UNITED STATES PATENT AND TRADEMARK OFFICE

APPLICATION NO.	FILING DATE	FIRST NAMED INVENTOR	ATTORNEY DOCKET NO.	CONFIRMATION NO.
10/630,443	07/30/2003	Jerry E. Bandstra	2-5169-049	9315

Office Action Summary

DETAILED ACTION

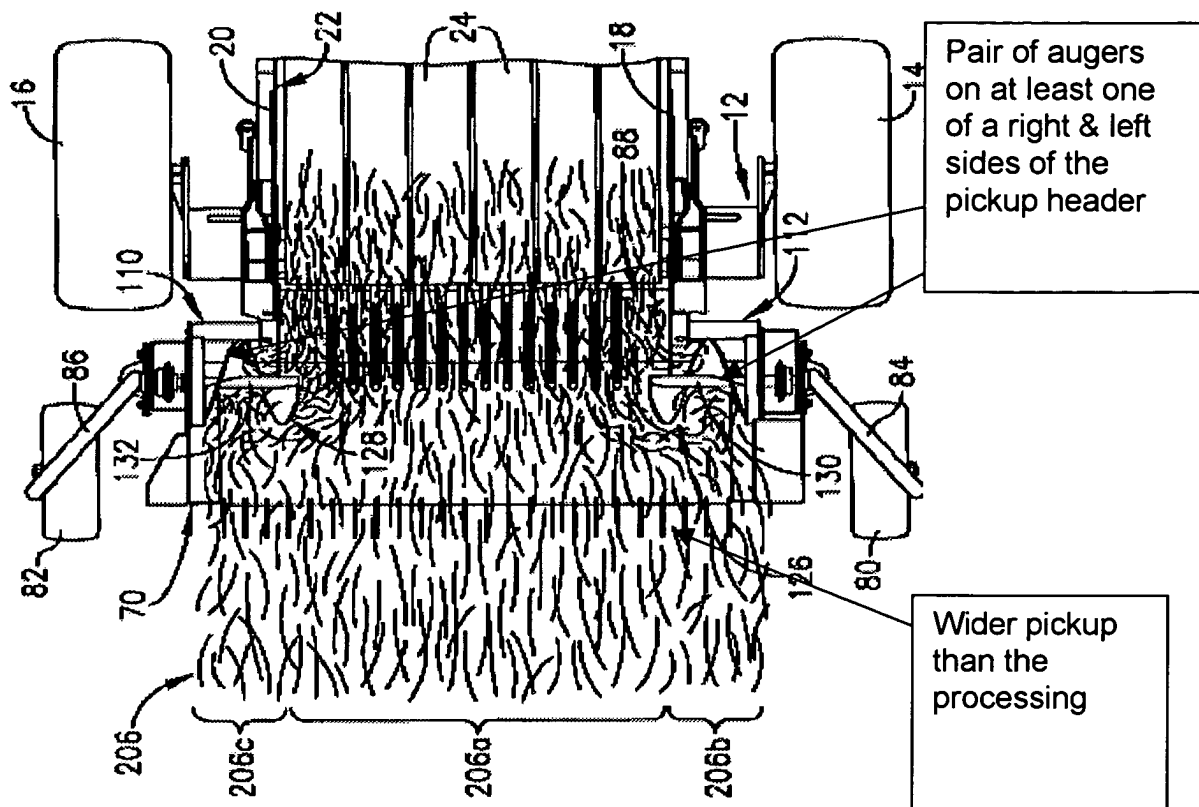
2. Claims 1, 8, 16 are rejected under 35 U.S.C. 102(b) as being anticipated by Ratzlaff et al (6029434).

In re claim 8. An apparatus for crop processing having a processing width defined by a distance between a left side and a right side of a processing unit, the apparatus comprising:

(a) a pickup header that is wider than said processing width (see fig 4 below);
and

(b) a pair of augers on at least one of a right side and a left side of the pickup header to move crop material laterally (see marked up fig below).

In re claim 16: wherein the apparatus for crop processing is a large round baler (see fig. 1 & 5).

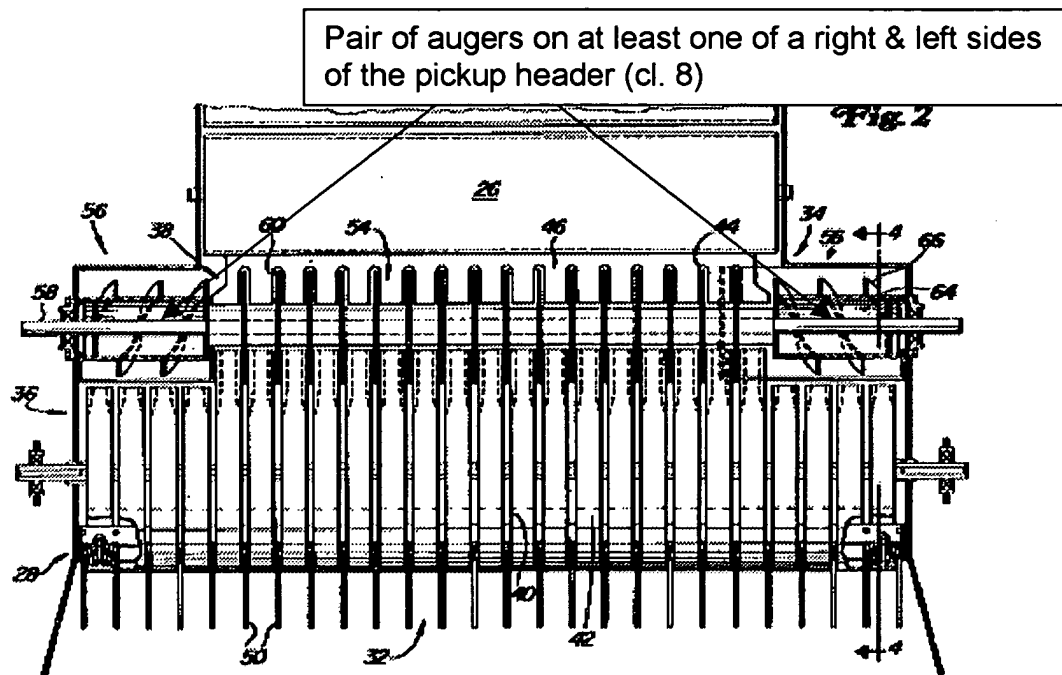
3. Claims 1, 8, 15, 16-17 are rejected under 35 U.S.C. 102(b) as being anticipated by Engel et al (5848523).

Applicant introduced new limitation of **not** having a gauge wheel to support the pickup header, accordingly, although this feature is well known in the art, as an example, Engel anticipates this feature:

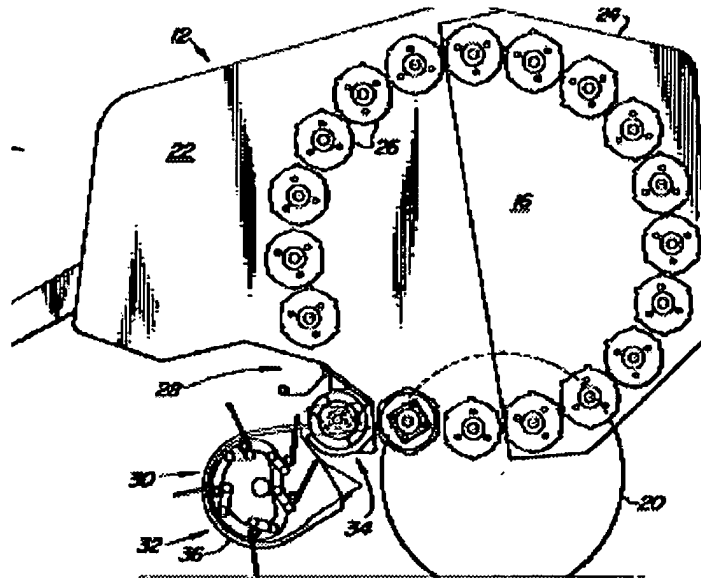
as shown below, there is no gauge wheel is being used (cl. 15, 17)
